ARCHITECTURAL REVIEW COMMISSION MEETING AGENDA

Department of Community and Economic Development
Meeting Date: September 12, 2019

2.1 (Project SPL-19-010)

2.3 (Project SPL-19-007)

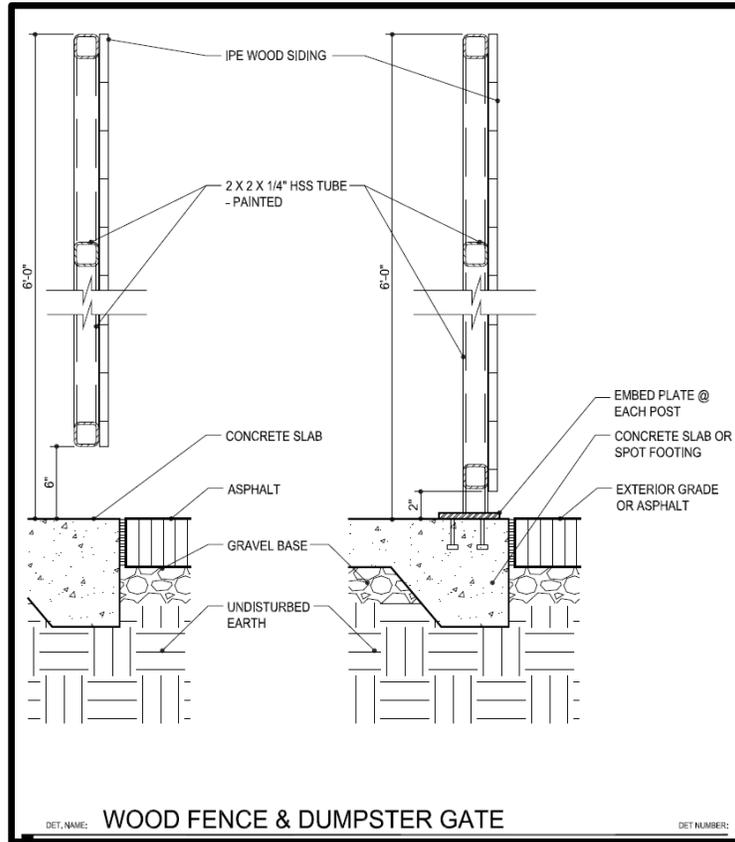
Recommendation: The applicant should provide additional detail for individual unit lighting. These could be delegated to staff for approval.

SIGN PLAN

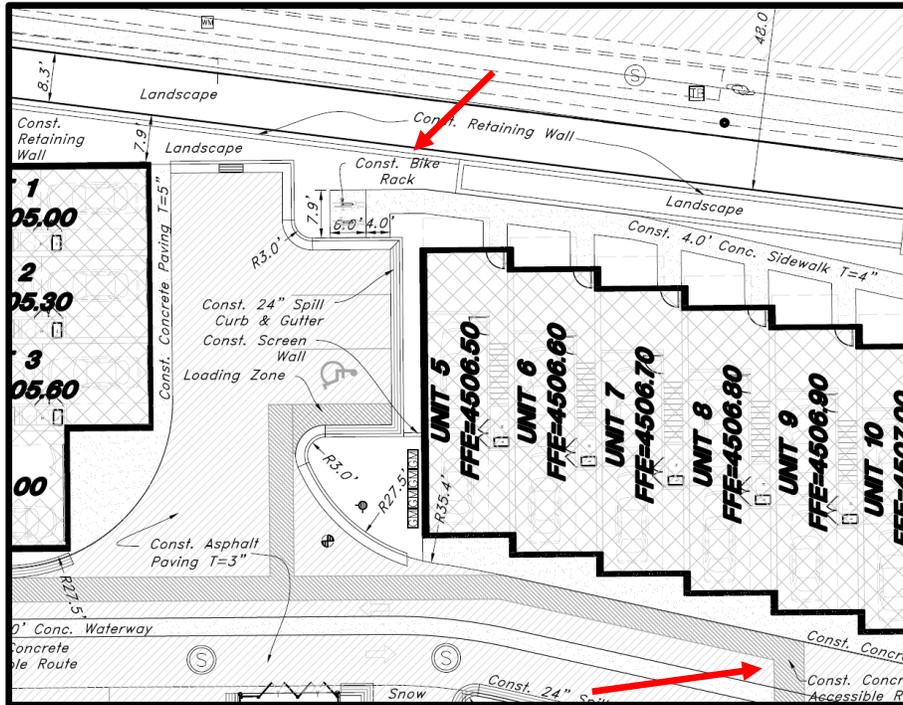
Commentary: The planning commission shall approve an overall signage plan during the site plan approval process. The applicant has provided a typical example of the sign plan on the building elevations.

Recommendation: Staff recommends that the applicant prepare a detailed sign plan that can be adopted by the Planning Commission as the required “sign plan” for the final plan documents. We also recommend conditions of approval that any additional signage be returned to the ARC and Planning Commission for review and approval. Further, we recommend that the sign plan is incorporated in the development’s CC&Rs with references to city code for modification of the sign plan.

PARKING

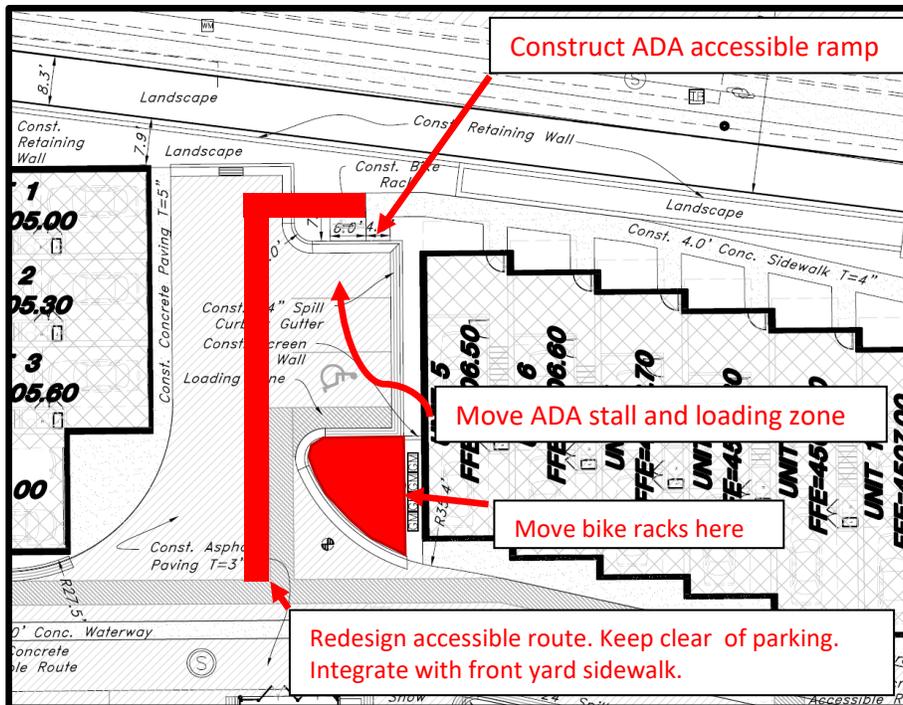
Design Guideline 28.3: Parking Lots Should Provide Areas for Bicycle... Parking.

Design Guideline 11. 3: Parking for residential aspects of mixed-used buildings should be well-marked and separate from commercial/business parking.

Commentary: The applicant has added bicycle parking since this issue was originally brought up. Internal access walkways have been identified as a “concrete accessible route” throughout the site.

Recommendation: The bicycle rack location, accessible route, lack of ADA ramps, and the dead-ending of the internal front-yard sidewalk into a parking space does not logistically work. The following amendments are recommended:

It is further recommended that the internal accessible route should be extended to the breezeway between the two primary buildings on Fort Union Blvd. and be also extended to the public sidewalk on
